**Project: Hurricane Laura Stom Repairs - Rosteet Annex**

**Addendum No. 2**

**Addendum Number 2**  
December 7, 2023

**Calcasieu Parish School Board**  
Rosteet Annex  
Engineer's Project Number: 23023

A1 WAREHOUSE WALL SECTION (TYPICAL)  
REFER TO RMG ARCHITECT SHEET A-2.3

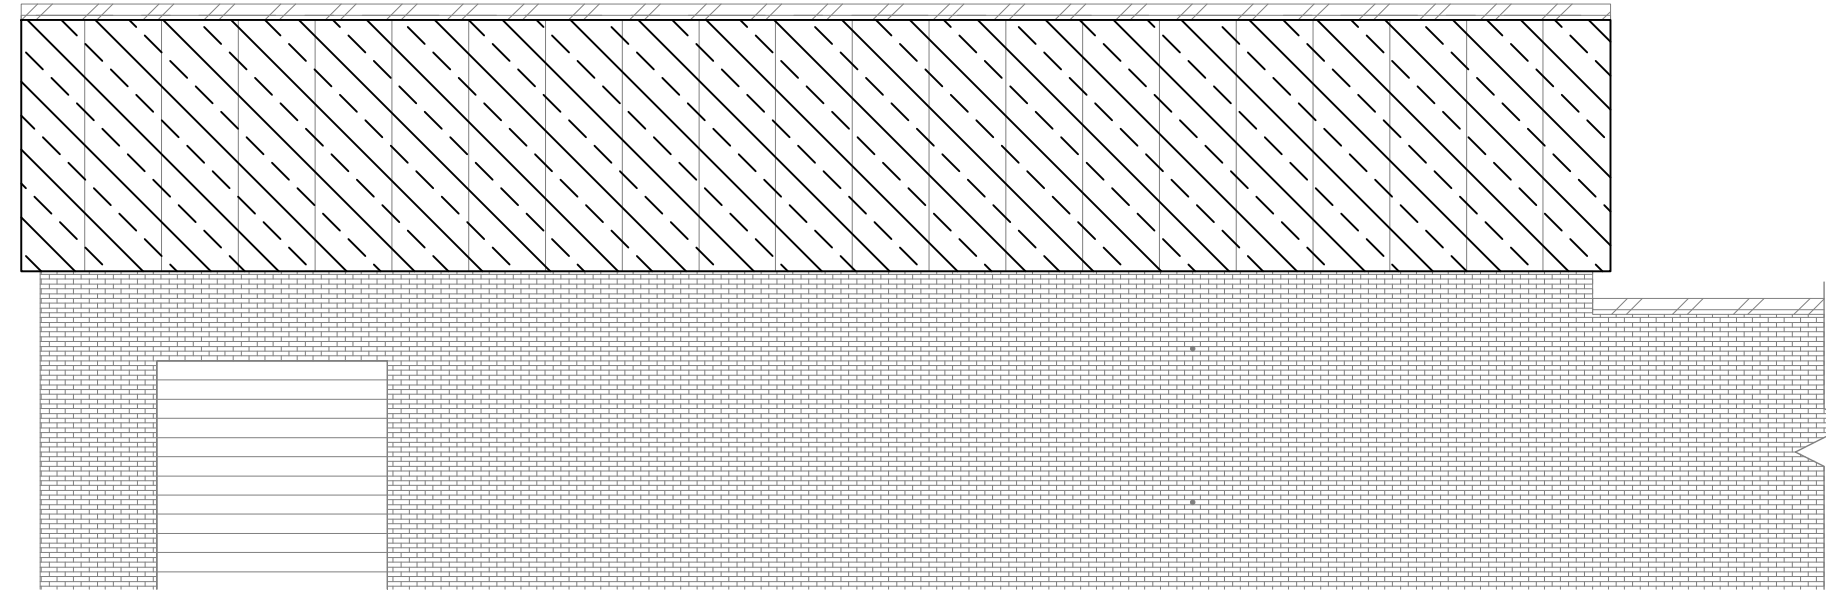
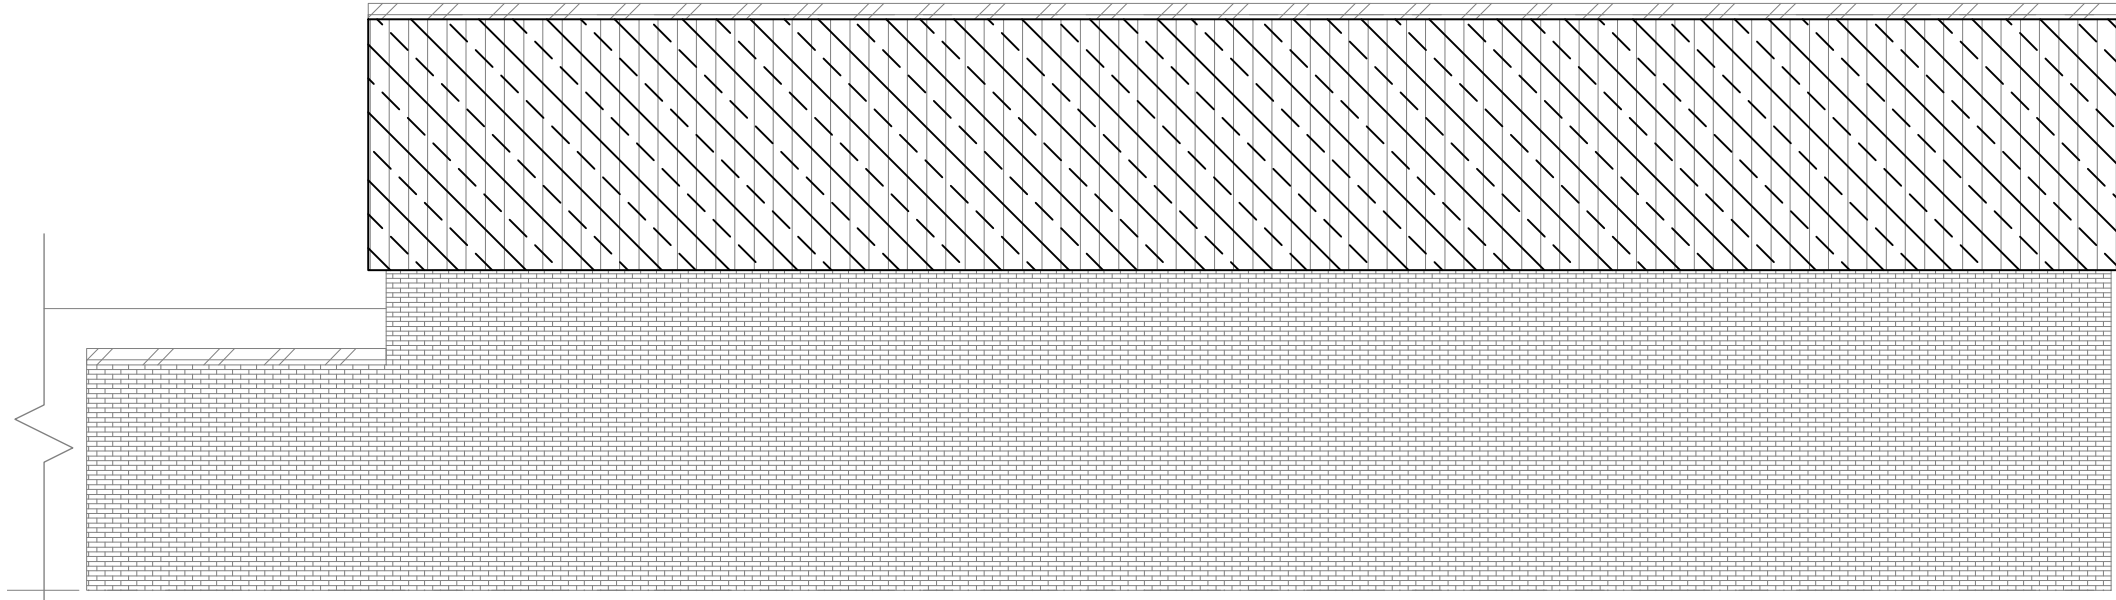
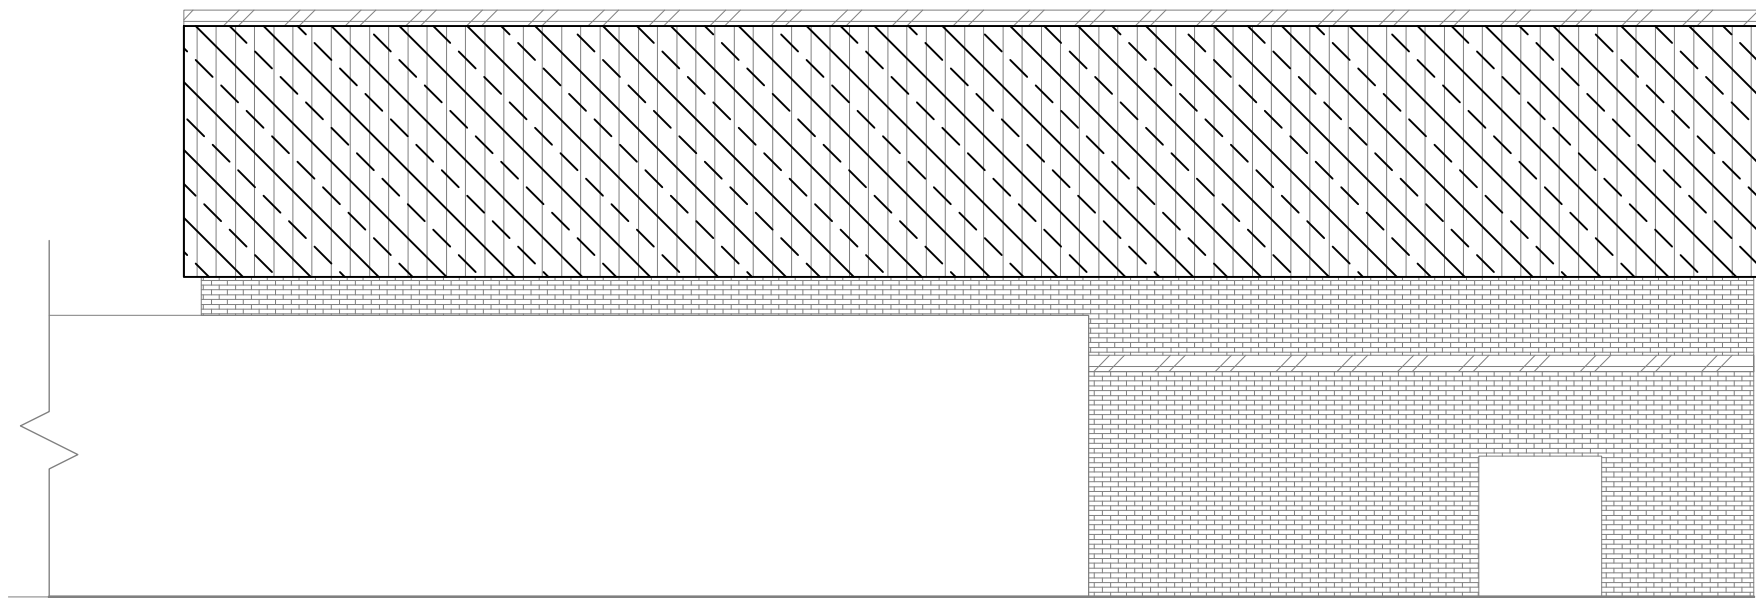
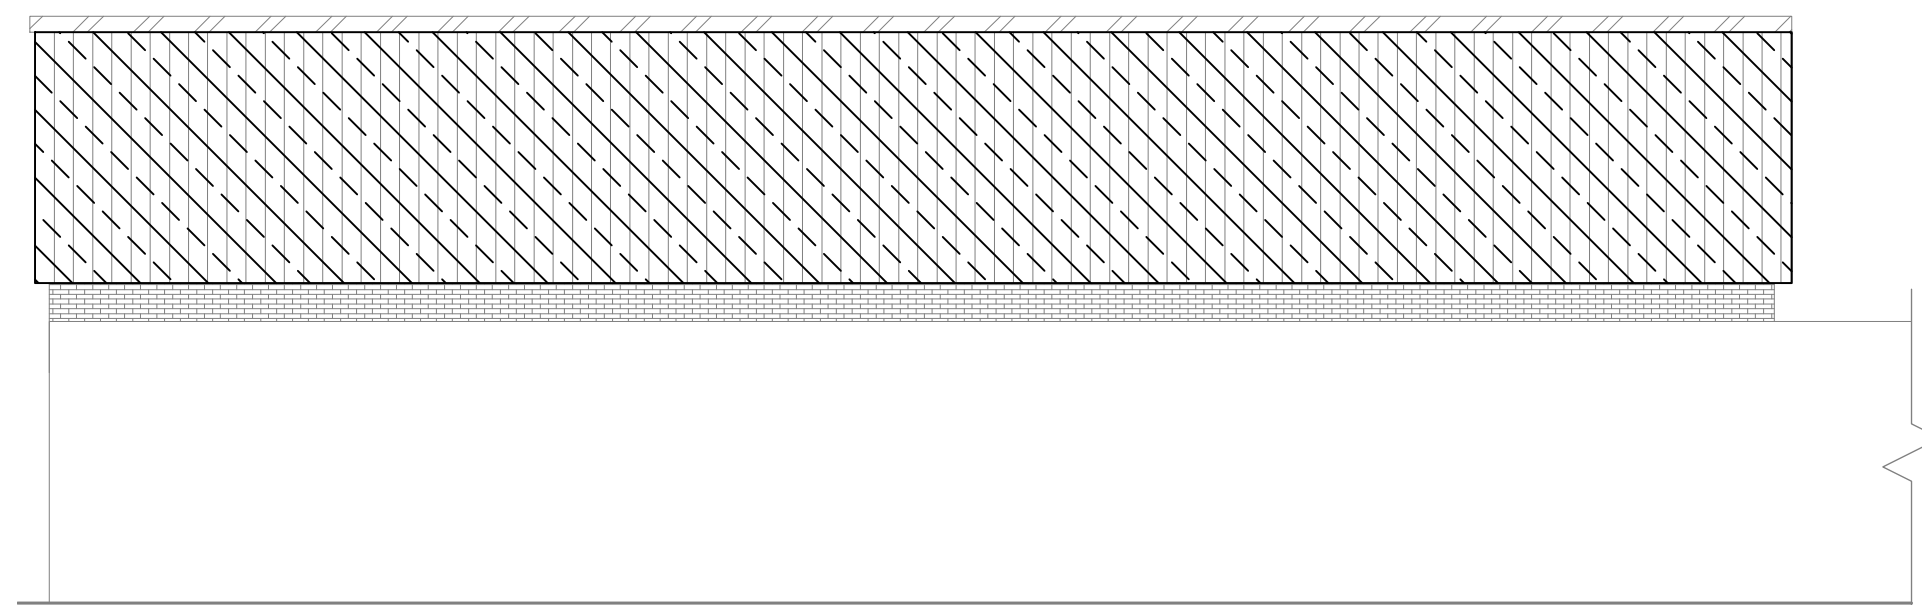
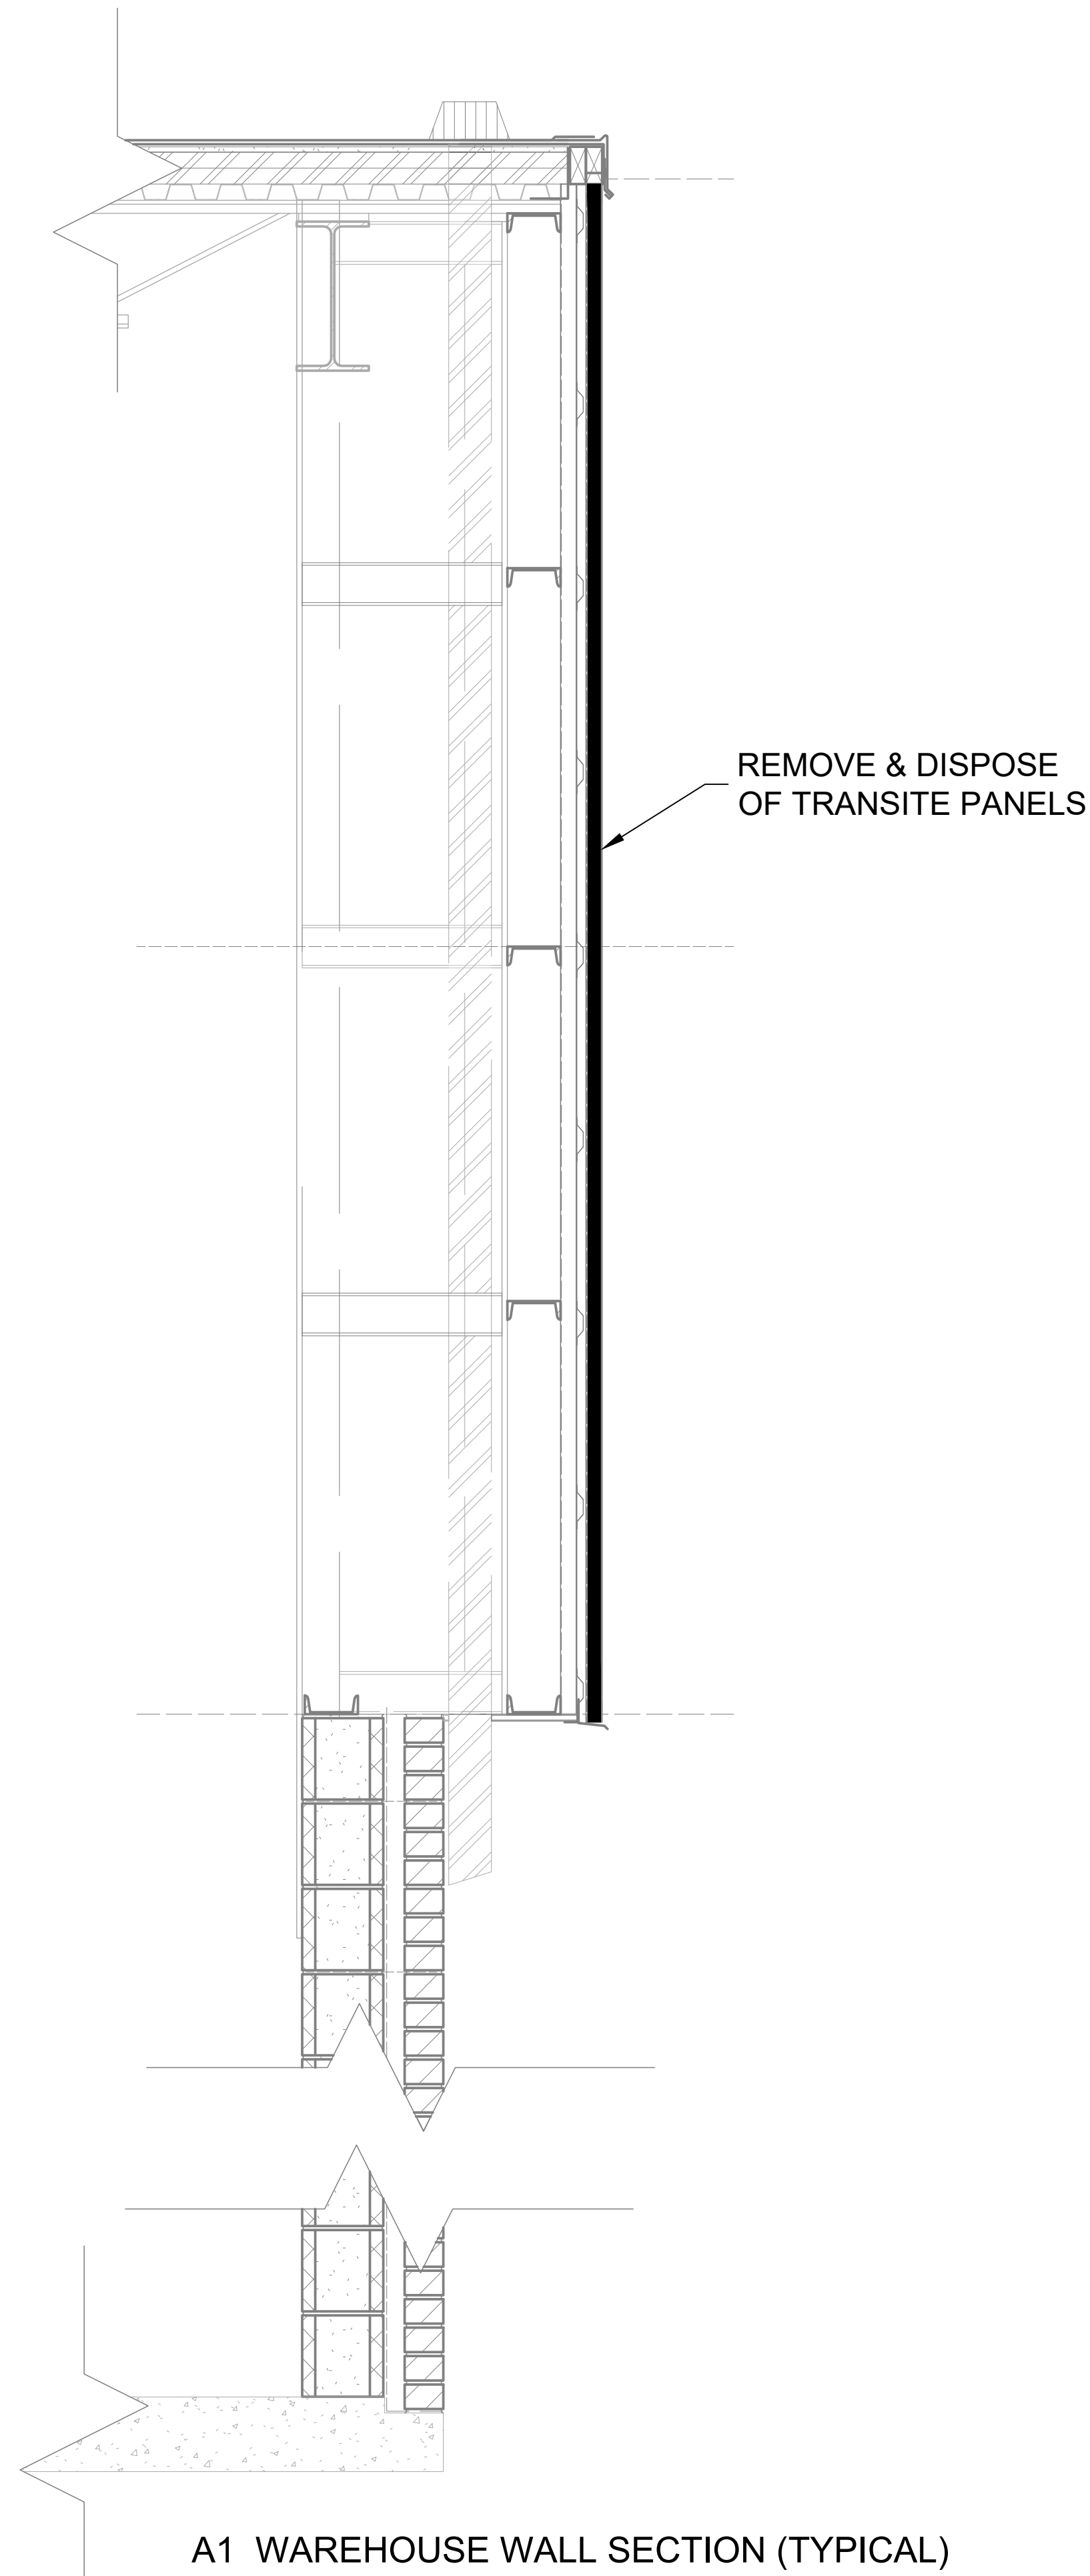
**Item 1** Delete Drawing Sheets ASB1, ASB2 and ASB3 and replace with attached Drawing Sheets ASB1, ASB2, and ASB3 dated 12/7/23.

REMOVE & DISPOSE  
OF TRANSITE PANELS

STAGE CURTAINS

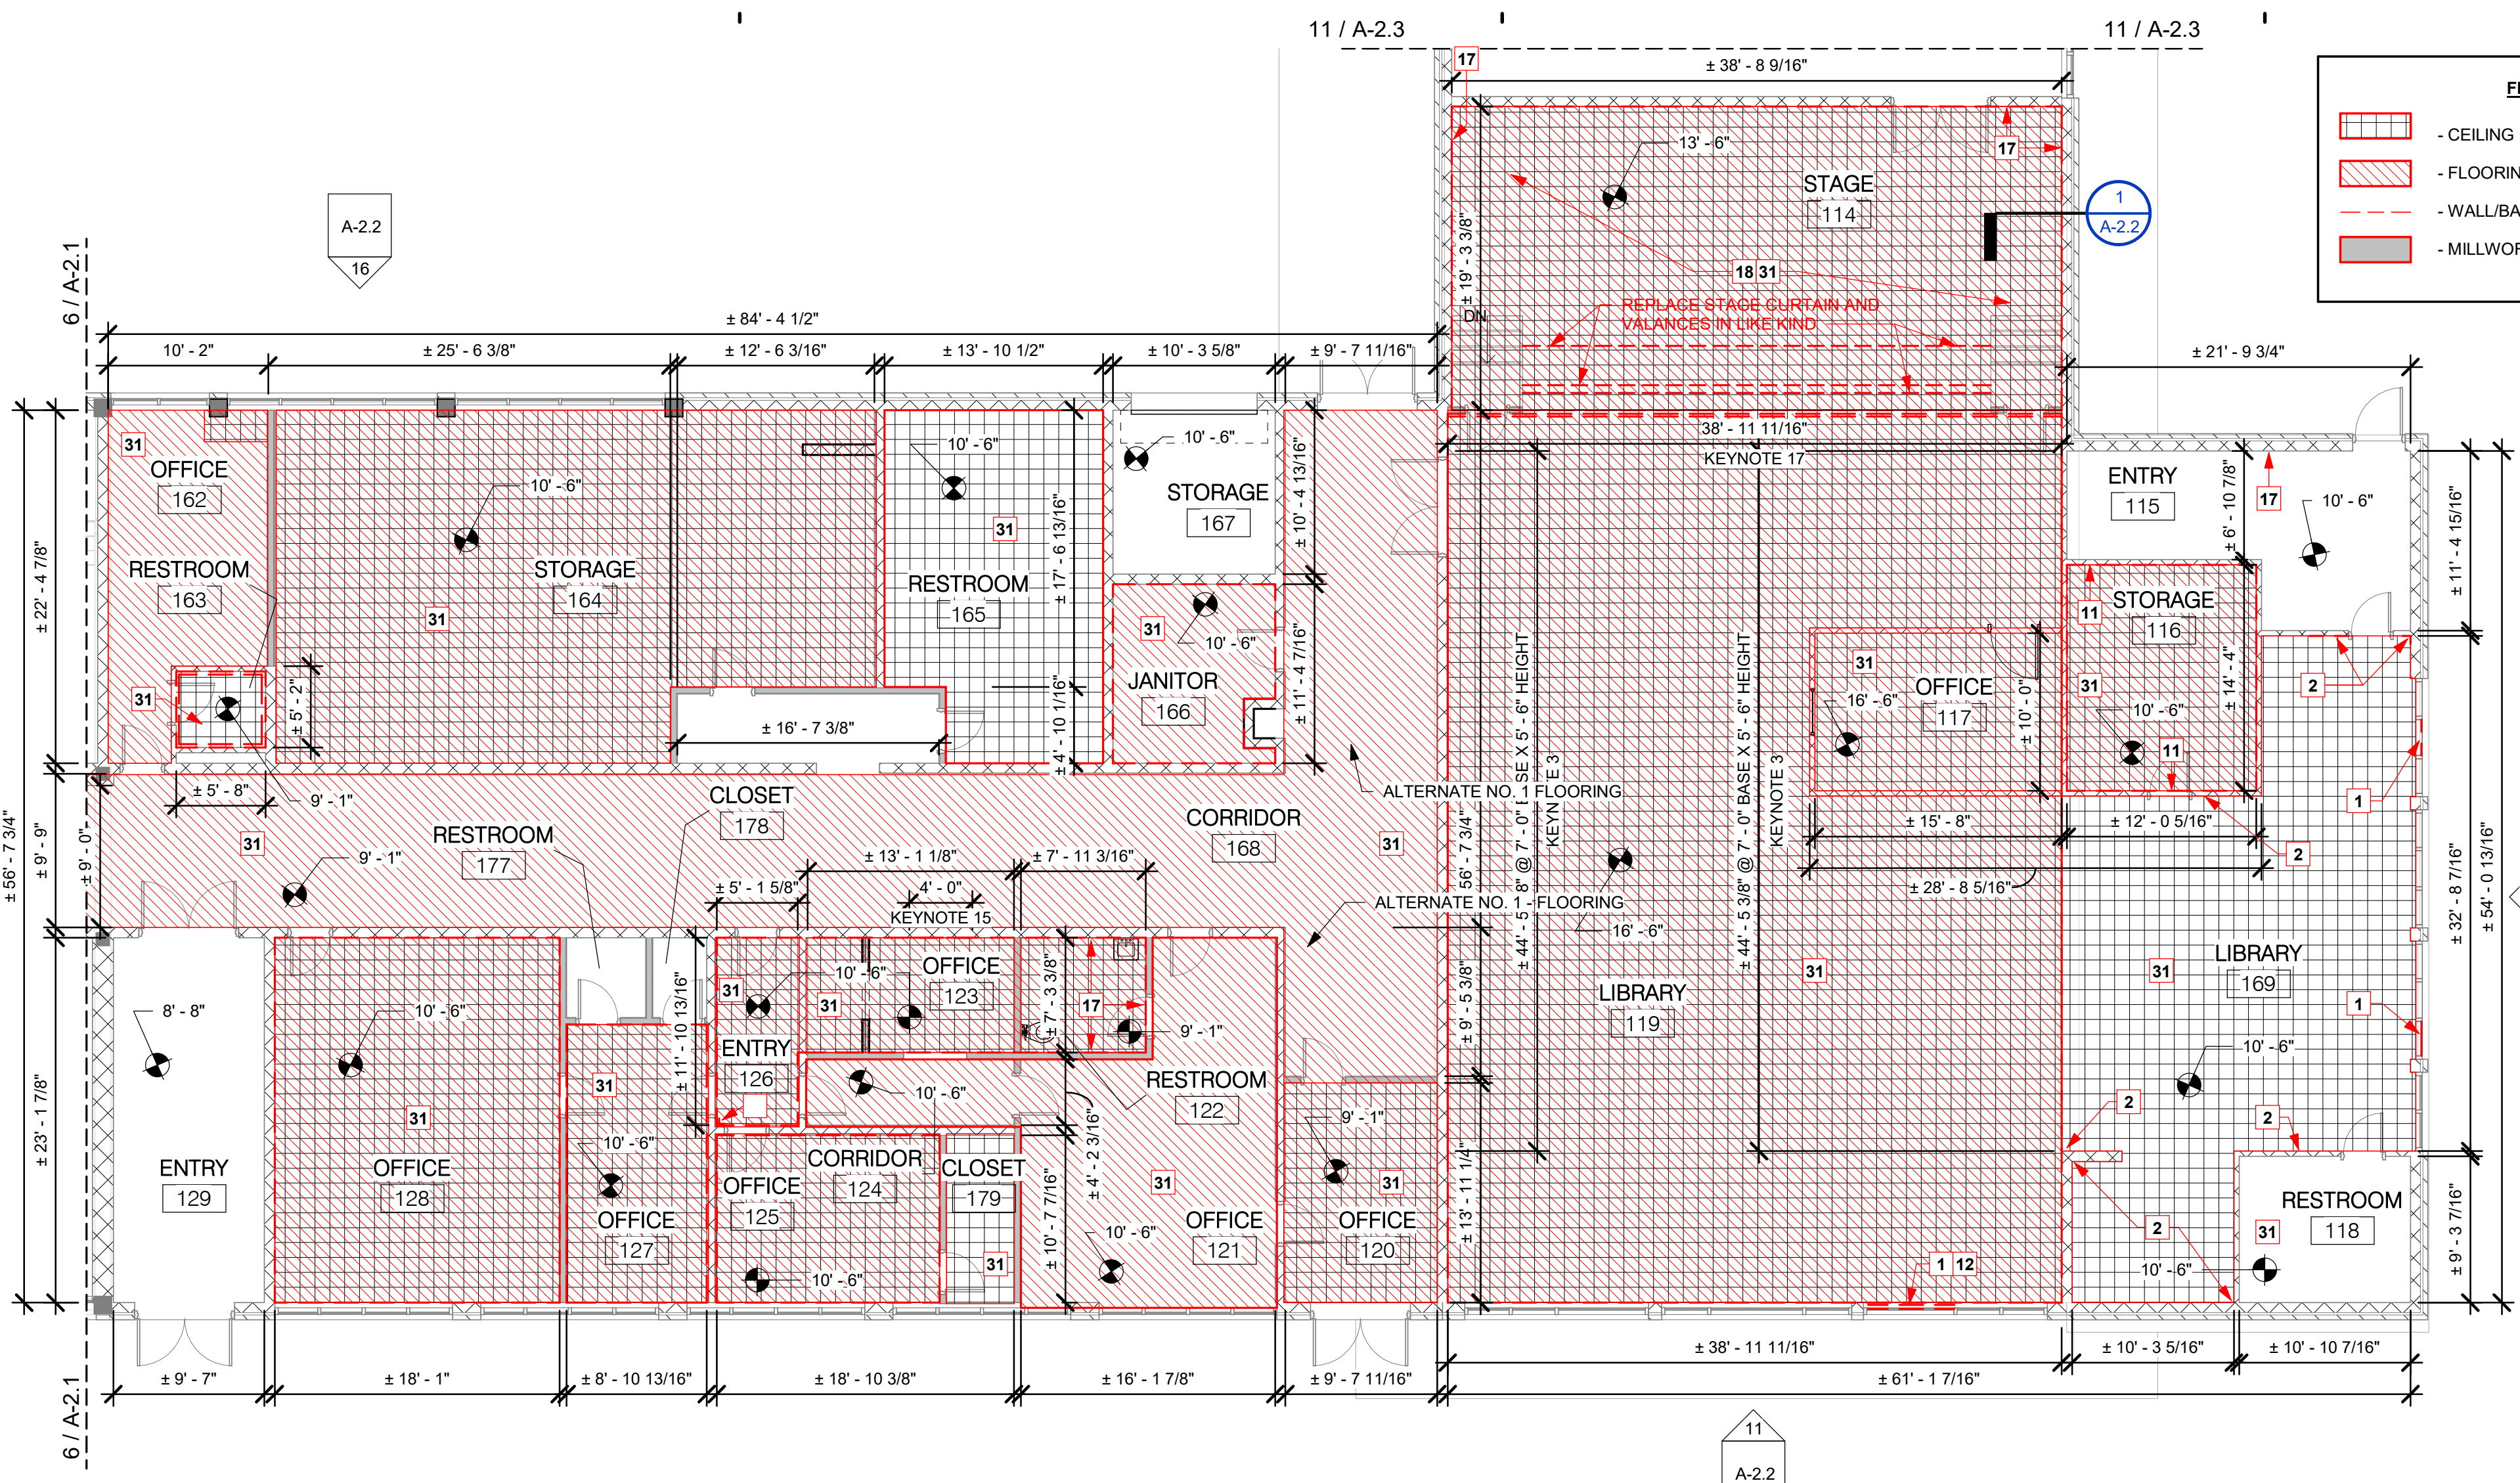
Item No. 3 - See attached photos of stage curtains to be replaced in like kind.
